**RESPONSE TO DEP COMMENTS
NOTICE OF INTENT
DEP FILE #274-25**

**YANKEE NUCLEAR POWER STATION
SITE CLOSURE PROJECT
ROWE, MASSACHUSETTS**

AUGUST 13, 2004

Figure 1 - Riverfront Area - Existing Conditions
Yankee Nuclear Power Station - Rowe, MA

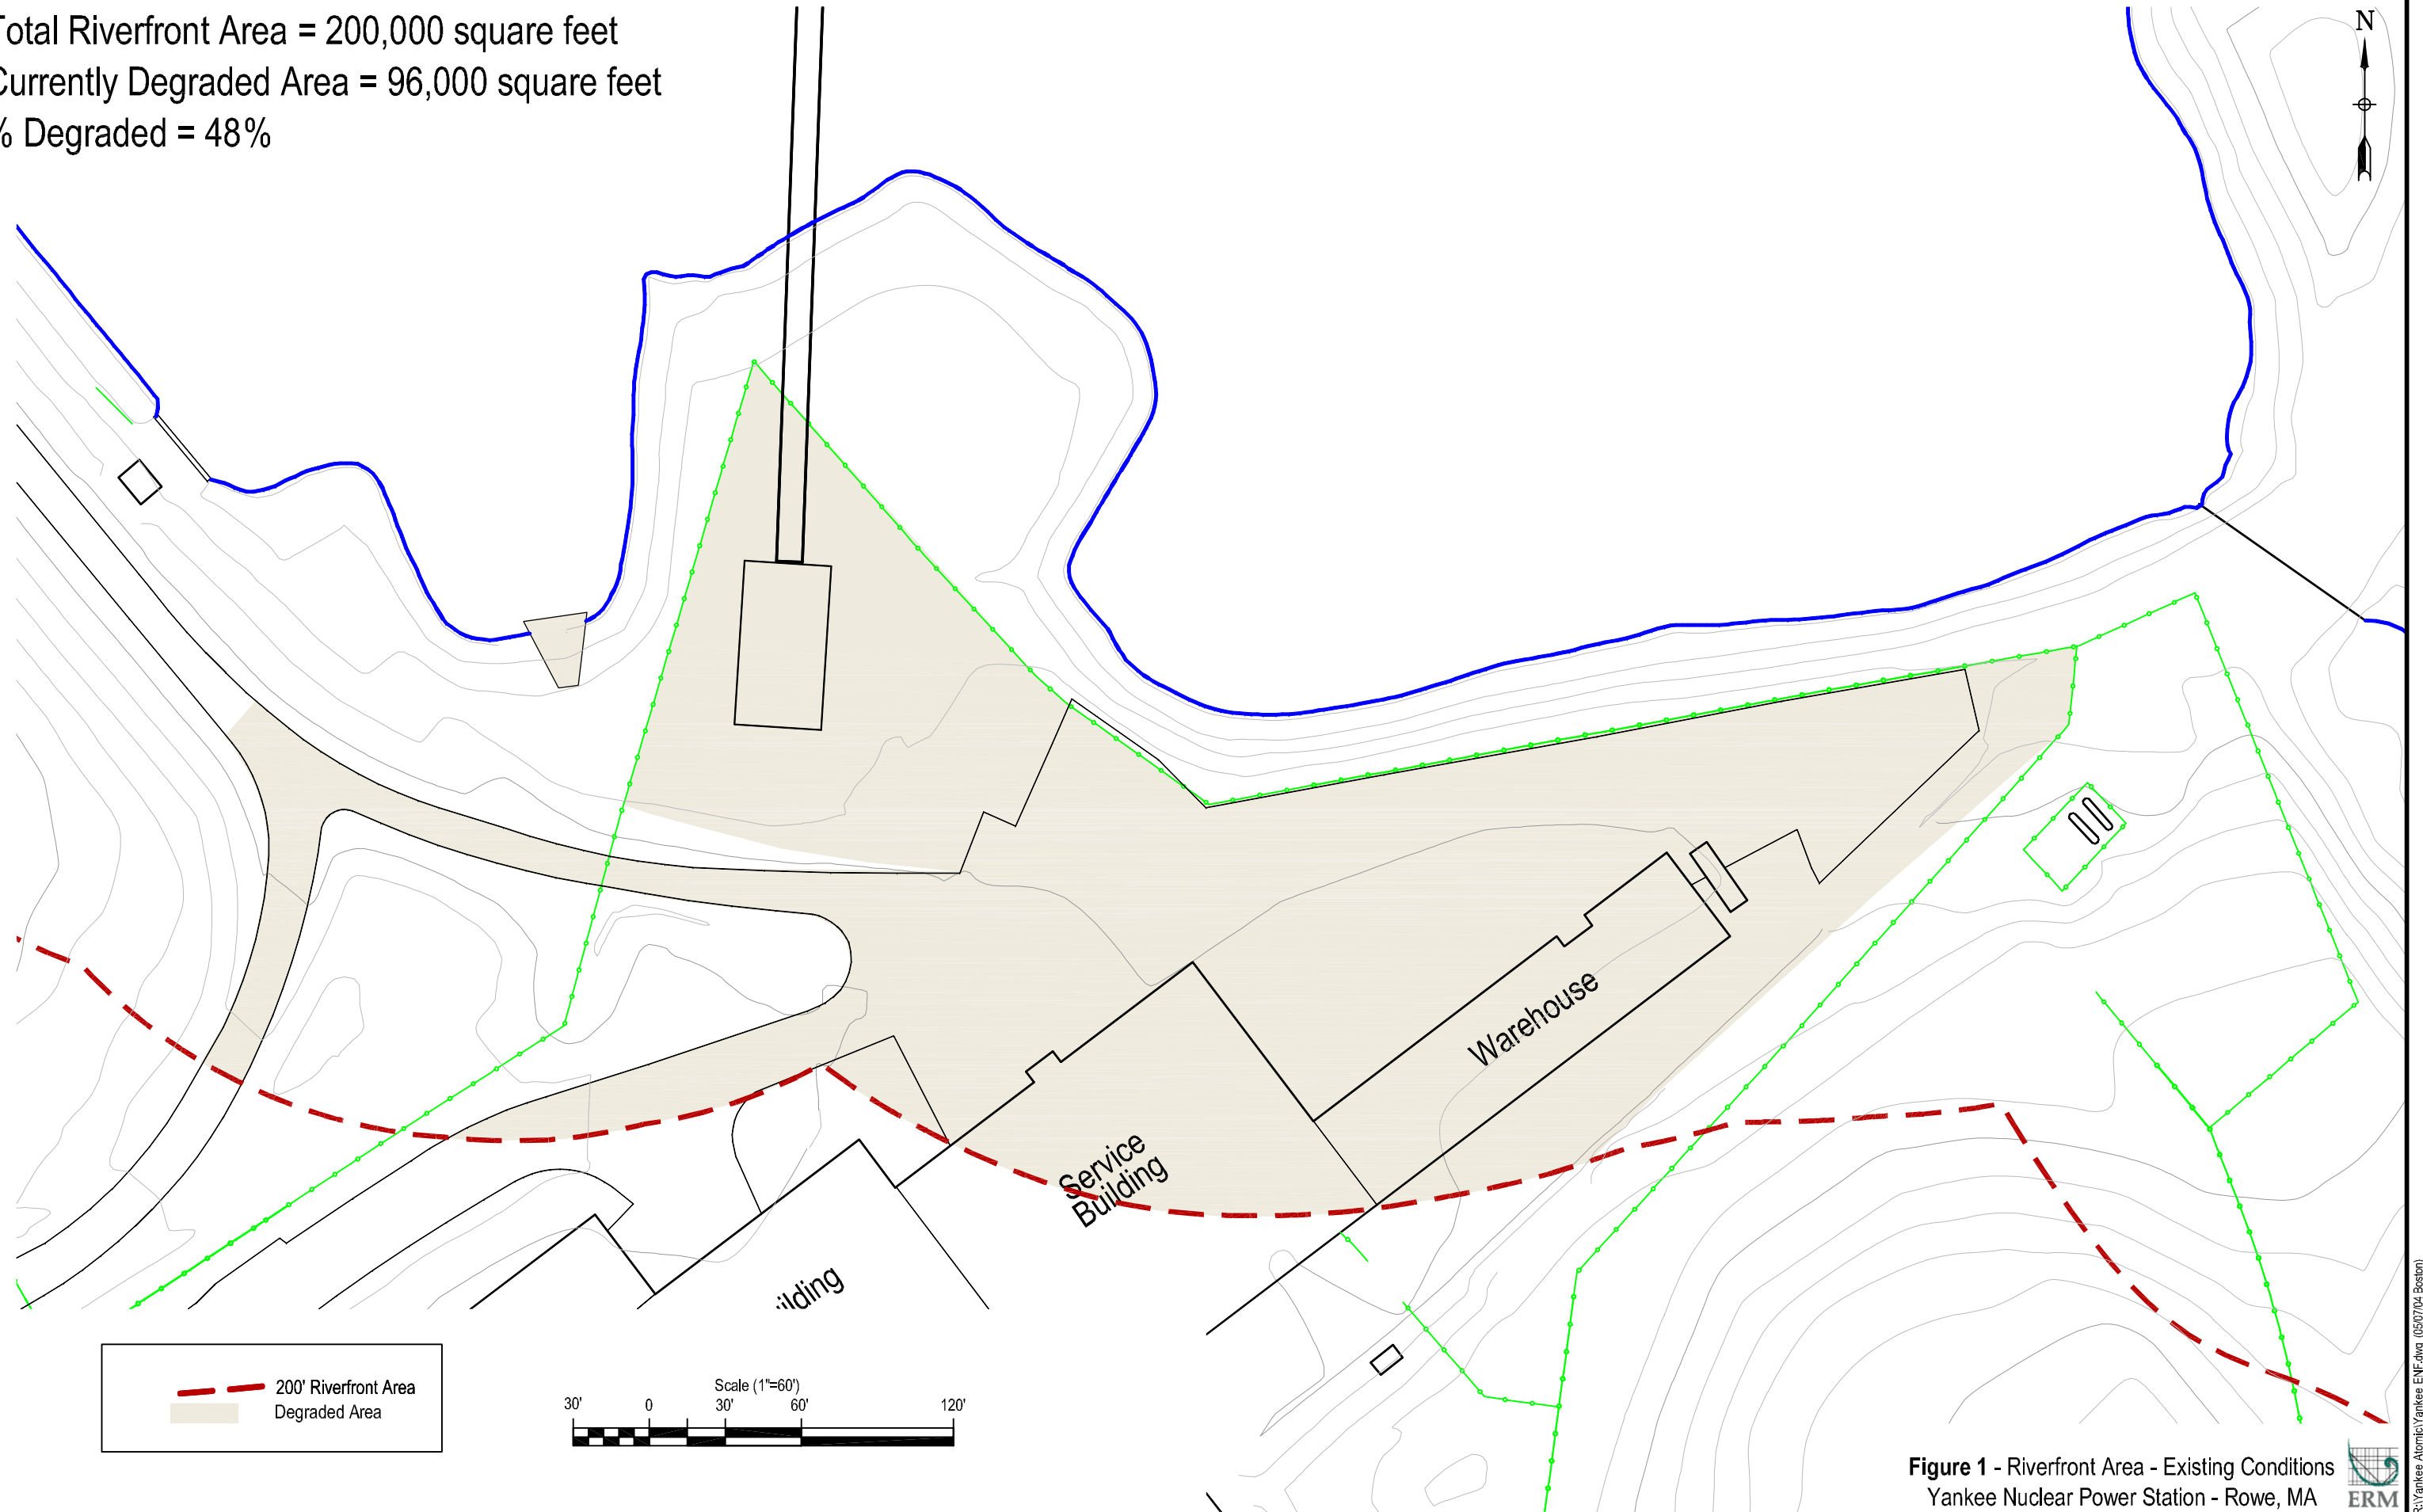
8. *310 CMR 10.58(5). See attachment. Removal of structures and impervious surfaces within Riverfront Area that are not also within other jurisdictional resource areas are exempt from 310 CMR 10.58 per 310 CMR 10.58(6)(b)6. As the applicant is already proposing soil amendments and plantings within the Riverfront Area of the Deerfield River, the ability to meet any requirements under 310 CMR 10.58(5)(f) and (h) may already be achievable, provided a planting list of indigenous species and a management plan under 310 CMR 10.58(5)(h) are submitted to the issuing authority and incorporated as part of an Order of Conditions.*

Response: The currently degraded portion of the site within the Riverfront Area is shown in Figure 1 and the proposed work area within the Riverfront Area is shown as Figure 2. The currently degraded area is estimated to be approximately 96,000 square feet. The proposed work area is estimated to be 120,000 square feet. Although the proposed work area is larger than the currently degraded area, YAEC plans to restore more than 24,000 square feet of the Riverfront Area through the removal of existing structures, covering the area with topsoil, and seeding and planting the area as described in the *Post-Decommissioning Planting Plan and Specifications*, which is being submitted concurrently with this submittal. YAEC intends to retain Woodlot Alternatives to monitor the plantings, as outlined in Section 7 in the *Post-Decommissioning Planting Plan and Specifications*. Therefore, the project will satisfy the provisions of 310 CMR 10.58(5)(f).
